NESC 2017 Changes Subcommittee 4 Clearances

NESC Workshop
San Antonio
October 11, 2016

SC4 Development of the NESC 2017

Rule 215C4a
2012 Code

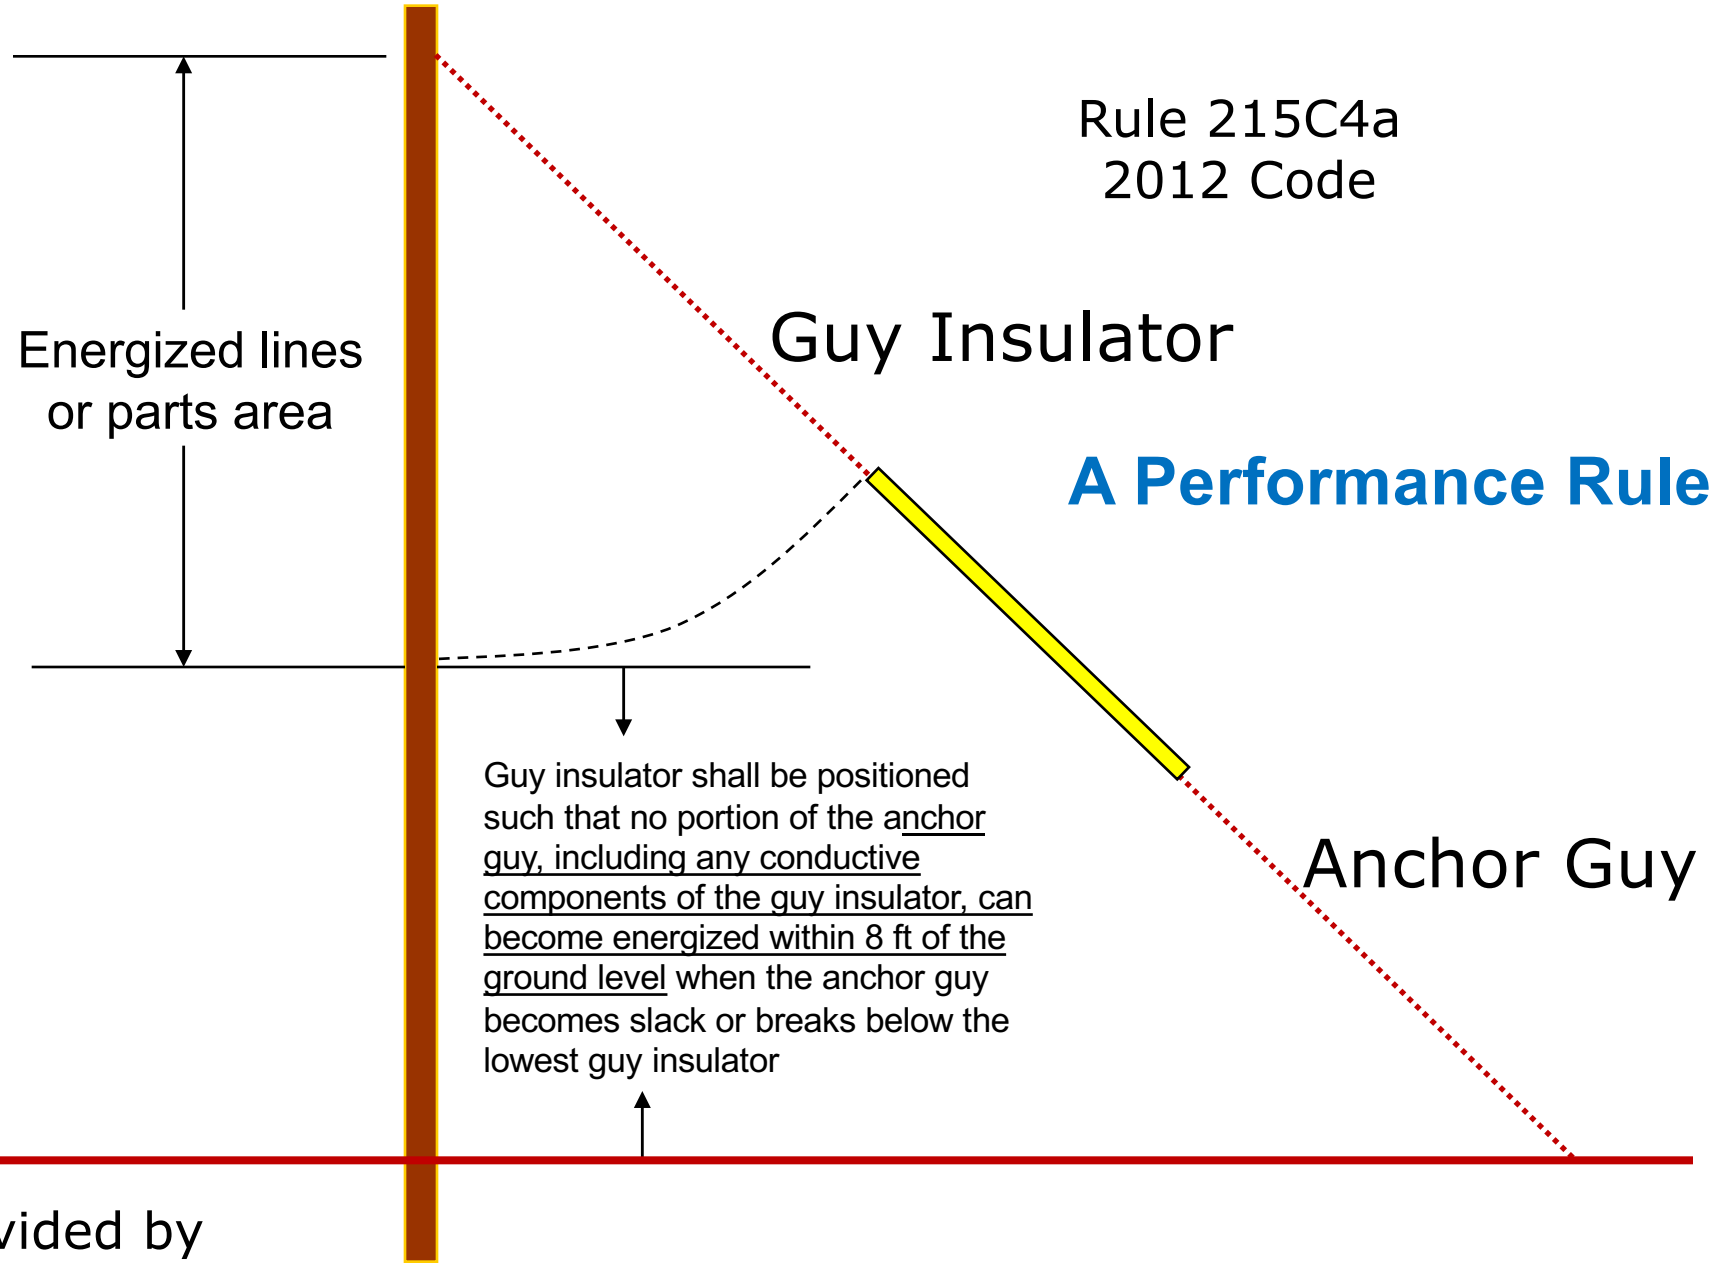
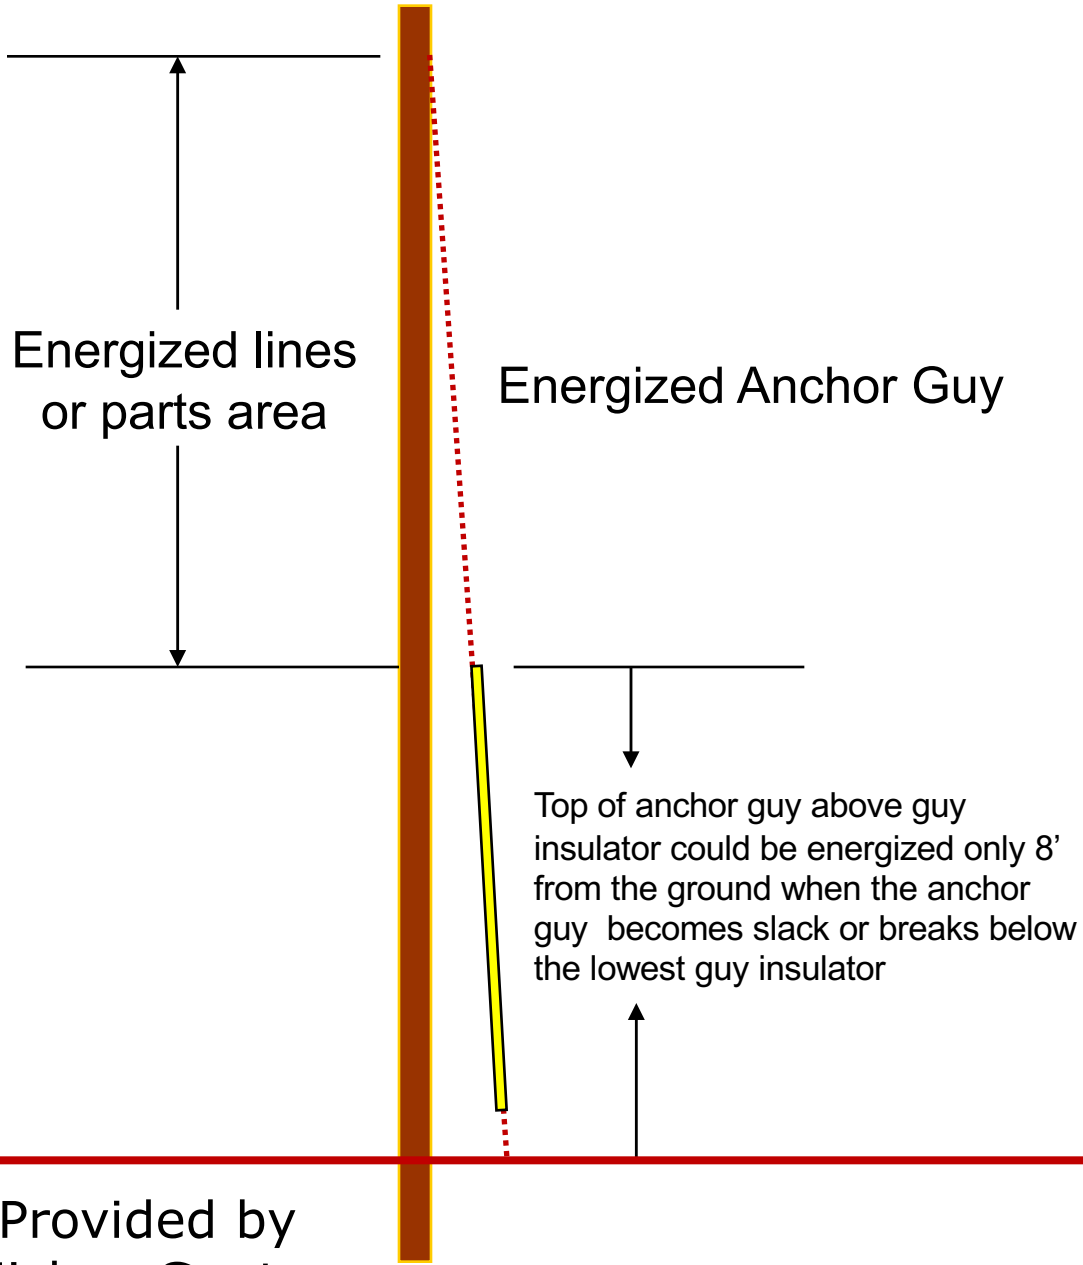
Change Proposal 4701 Accepted as Modified Guy Insulators

- Rule 215C2a for 2017 NESC Requires Anchor Guys to be Effectively Grounded
 - Not a new Code requirement
 - The installation of guy insulators is an exception to the grounding rule
- Exception 2 to Rule 215C2a:
 - Guy insulators shall be positioned so as to limit the likelihood of any portion of an anchor guy becoming energized within 2.45 m (8 ft) of the ground level in the event that the anchor guy becomes slack or breaks.

- Redefined How To Consider Clearances if Guy Wire Were to Break

From:

....in the event that the anchor guy becomes slack or *breaks below the lowest guy insulator.*

TO:

in the event that the anchor guy becomes slack or *breaks.*
